**Comments on Draft 2005 IEPR Transmission Chapter –  
The Sunrise Powerlink and Alternatives for  
Moving Renewable-Generated Electricity, Relieving  
Congestion, and Assuring Reliability in  
the Service Territory of the  
San Diego Gas & Electric Company**

**Utility Consumers' Action Network  
Border Power Plant Working Group**

**October 14, 2005**

**Figure 1. SDGE Region Transmission Reinforcement Options per LTRS Process**

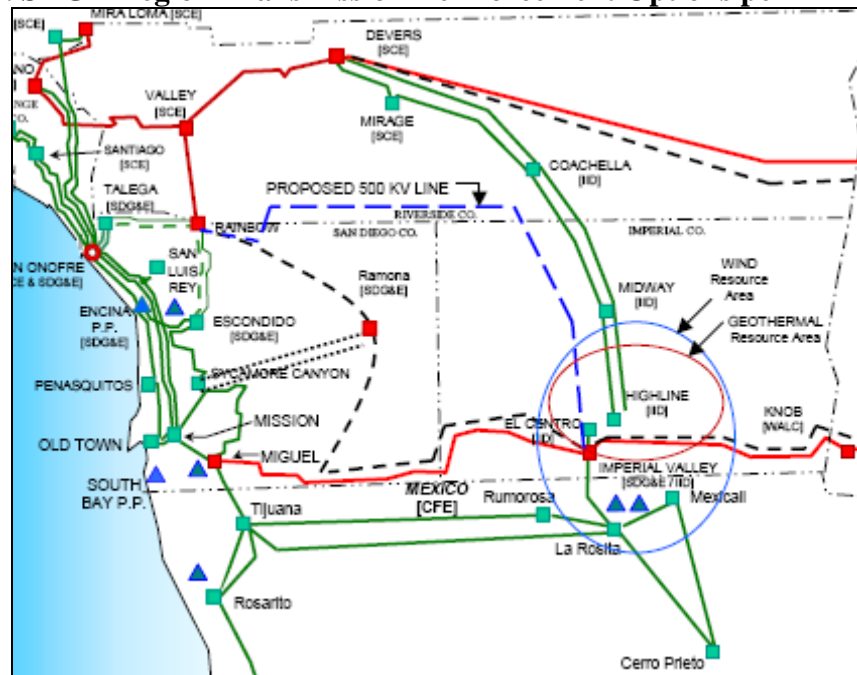
One 500 kV transmission proposal that was being promoted as optimum for the SDGE service territory in 2002 looks very similar to the route that will be followed (in part) by the proposed LADWP-IID 500 kV line. Shell Trading gave a presentation at the first Southwest Transmission Expansion Plan (STEP) meeting on November 1, 2002 that addressed transmission upgrade options under consideration in the Long Term Regional Study (LTRS) process. The graphic showing potential transmission reinforcement routes in the SDGE and SCE service territories is shown below as Figure 1.

The 500 kV LADWP-IID transmission line, which roughly follows the dashed blue line in Figure 1, is a superior alternative to the proposed Sunrise Powerlink for moving renewables out of Imperial Valley. It uses an existing 230 kV corridor that passes through lands of minimum environmental sensitivity, fully consistent with the Garamendi principle regarding transmission corridor selection. In contrast, the Sunrise Powerlink is effectively a greenfield 500 kV line that will traverse the Anza Borrego State Park and relatively undeveloped San Diego County backcountry.

**Figure 2. Current and Proposed High Voltage Transmission Projects in Region**

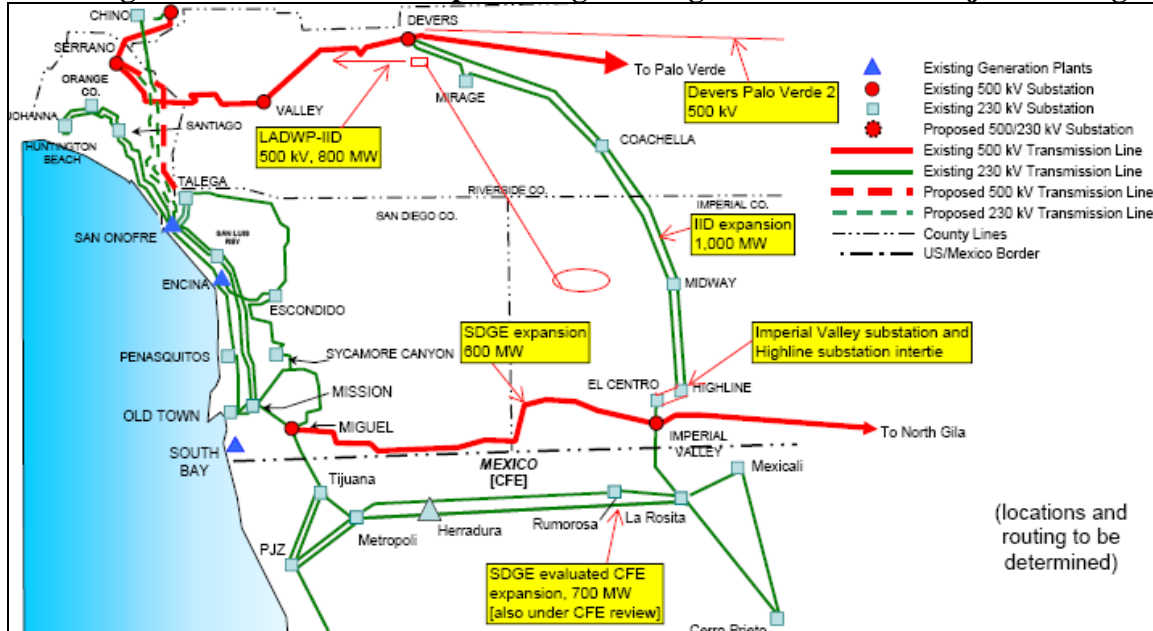
It is also important to point out that the strip of land including the Mexican border up to the DVP1 transmission line will be quite saturated with high voltage transmission lines even without the Sunrise Powerlink. Current and proposed transmission projects, not including the Sunrise Powerlink, are shown in Figure 2.

As shown in Figure 2, SDGE already has two transmission outlets from Imperial Valley to move renewables – the newly upgraded 500 kV SWPL (upgraded from 1,300 to 1,900 MW) and the two 230 kV transmission lines 10 to 15 miles south of SWPL in Mexico. SWPL will be available to move renewables from Imperial Valley as soon as the interconnection with IID Path 42 at the Imperial Valley substation is complete. This interconnection is a component of IID’s planned transmission upgrade project.

Two other high voltage paths move renewable power north and west from Imperial Valley. These are 1) the existing IID Path 42 interconnect with SCE at Devers, and 2) the proposed 500 kV LADWP-IID transmission link. The Sunrise Powerlink will be the fifth transmission link to the Imperial Valley renewables area in a distance of approximately 100 miles.
